ADDENDUM

Project: Wayne State College
Student Center
Electrical Distribution Panel

Project No.: 2013-100

Addendum No.: 1

1 ELECTRICAL ONE-LINE DIAGRAM

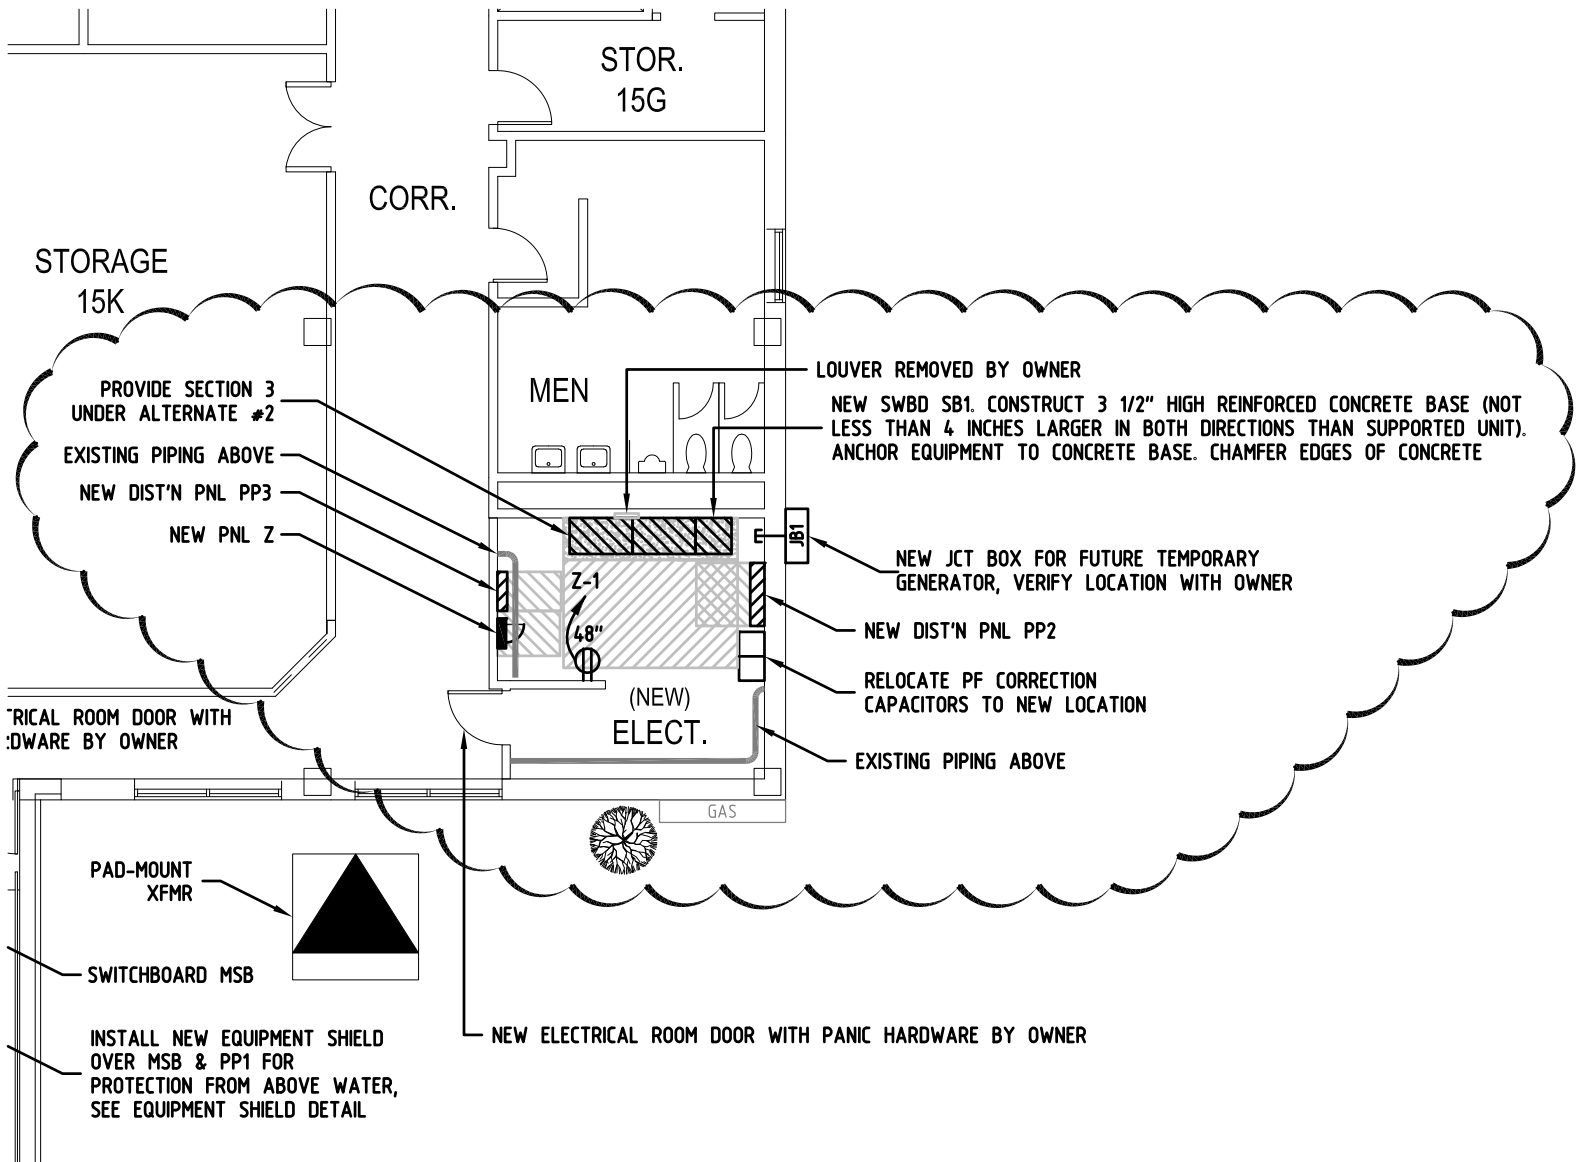
1. Provide 200/3 sub-feed circuit breaker in panel 'KP1' for panel 'S' in lieu of 225/3. Revise feeder to panel 'S' to 4-#3/0 plus 1-#6 gnd in existing 2" C. See attached drawing AD01.E5-1.
2. A fault current and overcurrent protective device coordination study shall be completed by the electrical equipment manufacturer & applied to the new electrical distribution system and all new adjustable electronic trip breakers. The cost of the study shall be incurred by the contractor & included in their bid. Provide all data acquisition to the electrical equipment manufacturer. This shall include, but not limited to, conduit types/lengths, wire type/lengths & all lineal footage of conduit/wire runs, etc. to accurately determine available fault current & OCPD coordination.

AD01.E2-1

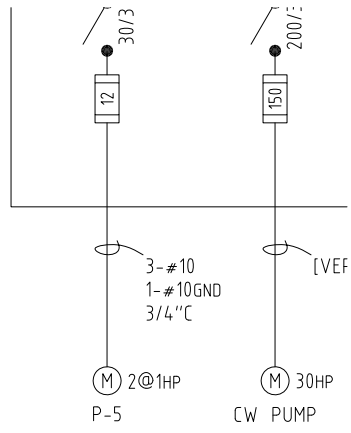
1. Revise electrical room layout to accommodate existing piping. See attached drawing AD01.E2-1.
2. Relocate junction box 'JB1' to east side of building. Verify location with owner prior to installation. See attached drawing AD01.E2-1.
